ROYAL NORTH SHORE HOSPITAL CLINICAL SERVICES

Project Code: 220977
 Drawing No: 0206
 Date: 08/08/11
 Scale: B

**DRAFT NSW Health VR38 -
Diversion of 500mm and 200mm
Watermains**

Re: Royal North Shore Hospital PPP Project NSW Health Variation Request 38

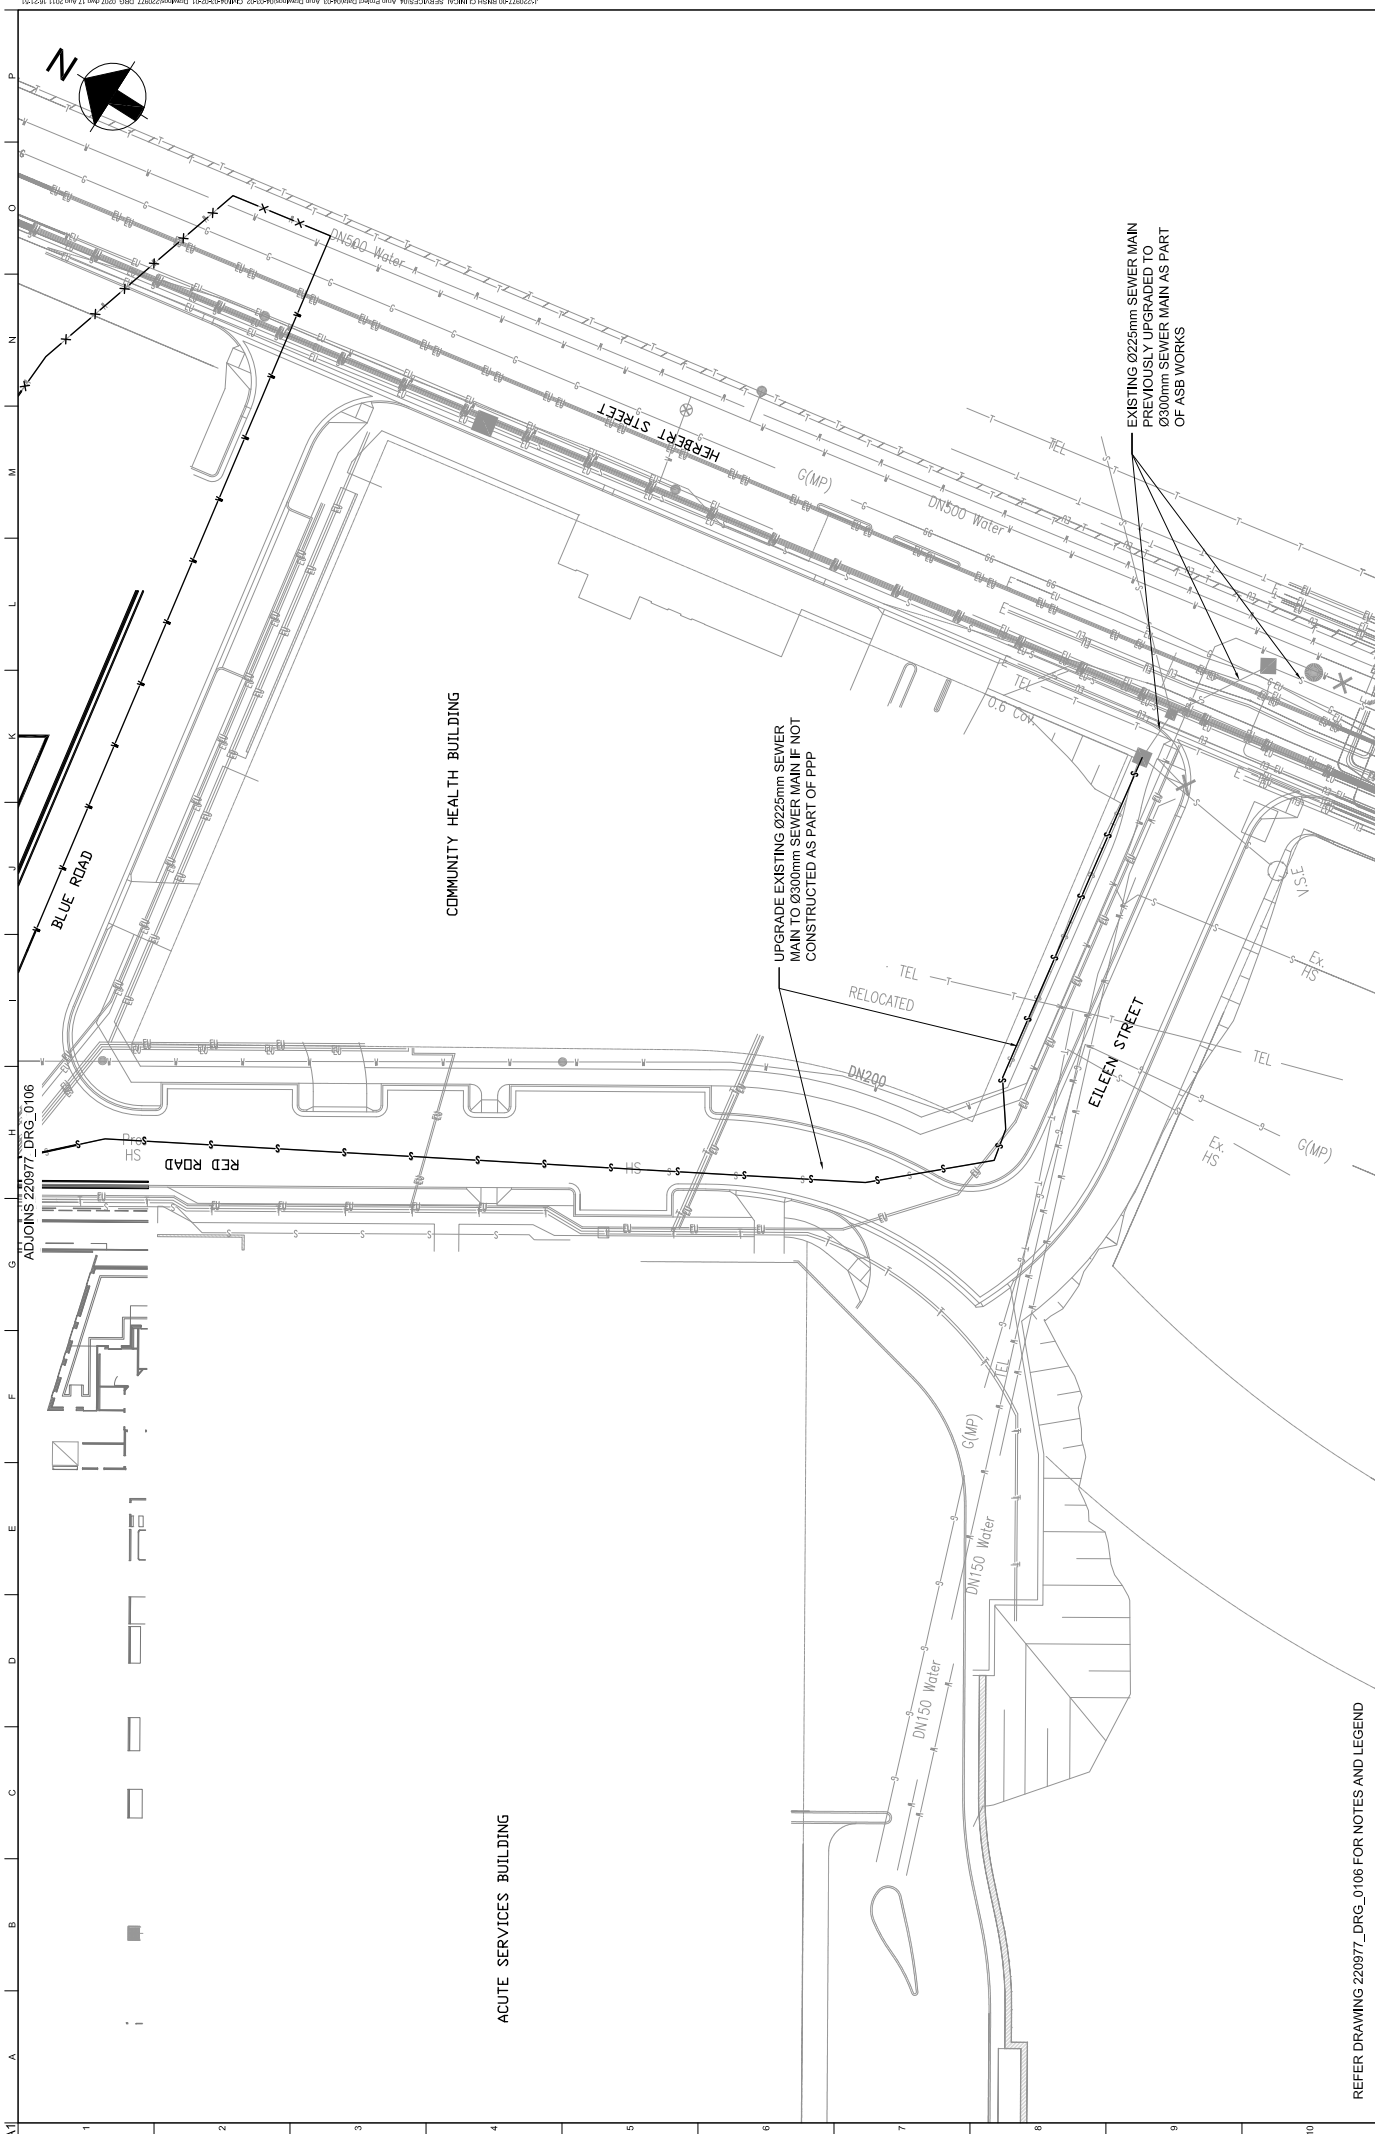
EXISTING SEWER MAIN APPEARS TO BE ORPHANED. FURTHER INVESTIGATION REQUIRED DURING DETAIL DESIGN.

EXISTING Ø600mm WATER MAIN TO BE BUILT OVER SUBJECT TO SYDNEY WATER APPROVAL.

POSSIBLE FUTURE Ø300mm CONNECTION TO EASTERN SIDE OF CSB. LOCATION DEPENDENT ON SUFFICIENT VERTICAL CLEARANCE TO WATER MAIN

NEW Ø300mm CONNECTION TO CSB - LOCATION BASED ON SYDNEY WATER FEASIBILITY LETTER DATED 16/12/10

EXISTING SEWER MAIN WILL REQUIRE RELOCATION WHILE MAINTAINING SERVICE TO KOLLING BUILDING

PROPOSED LOCATION FOR RELOCATED SEWER MAIN. SUBJECT TO SYDNEY WATER APPROVAL. ALIGNMENT TO BE CONFIRMED.

UNIDENTIFIED SEWER MAIN POSSIBLY ORIGINAL CONNECTION POINT FOR MENTAL HEALTH BUILDING. FURTHER INVESTIGATION REQUIRED DURING DETAIL DESIGN

EXISTING Ø600mm WATER MAIN TO BE RELOCATED.

PROPOSED RELOCATION OF EXISTING Ø600mm WATER MAIN ROUTE SELECTED BY HI. ALIGNMENT INDICATE ONLY AND MAY CHANGE DEPENDING OF EASEMENT REQUIREMENTS.

UPGRADE EXISTING Ø225 SEWER MAIN TO Ø300 SEWER MAIN IF NOT CONSTRUCTED AS PART OF PPP
